ADDENDUM E-1

September 1, 2026

Chippewa Downs Grandstand
Belcourt, North Dakota
Project #26028

PRAIRIE ENGINEERING, P.C.
1905 17TH ST SE
MINOT, NORTH DAKOTA

1
E5.0
ELECTRICAL GRANDSTAND PLAN
1/8" = 1'
N

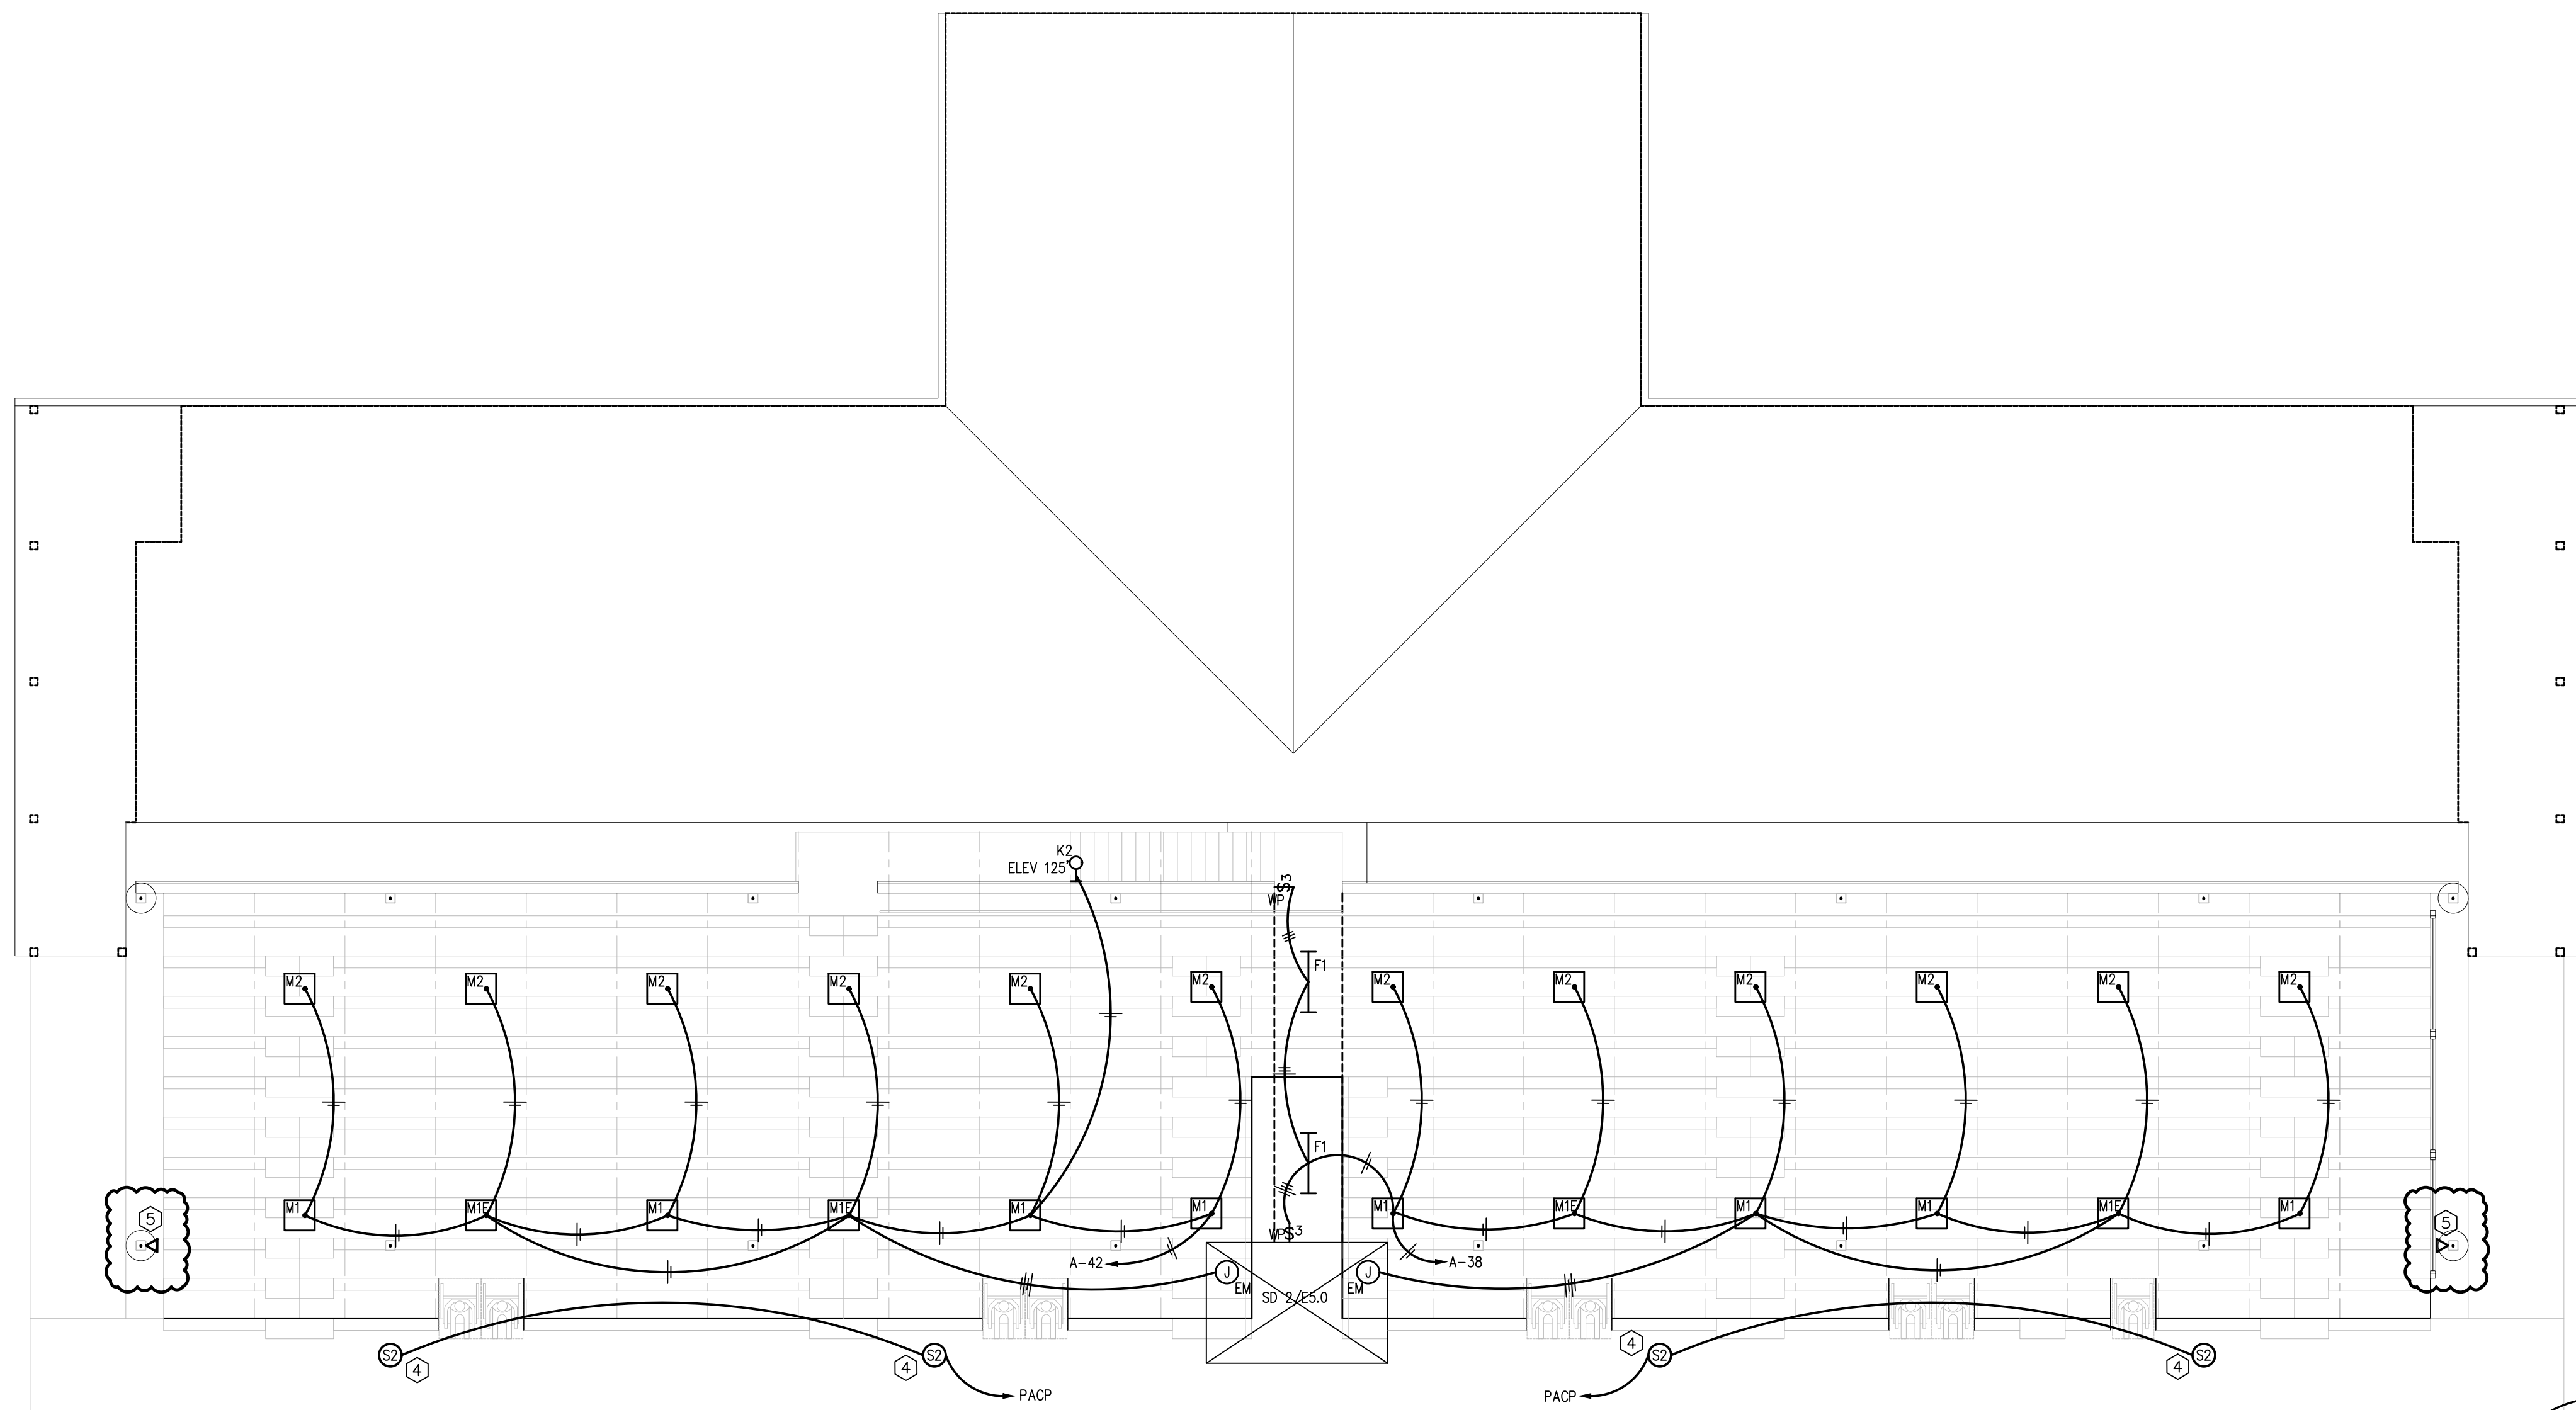
DRAWING ITEM #5. Detail 1/E5.0

- A. Added Keynote 5 for cameras on the grandstand supports.
- B. Added cameras locations.
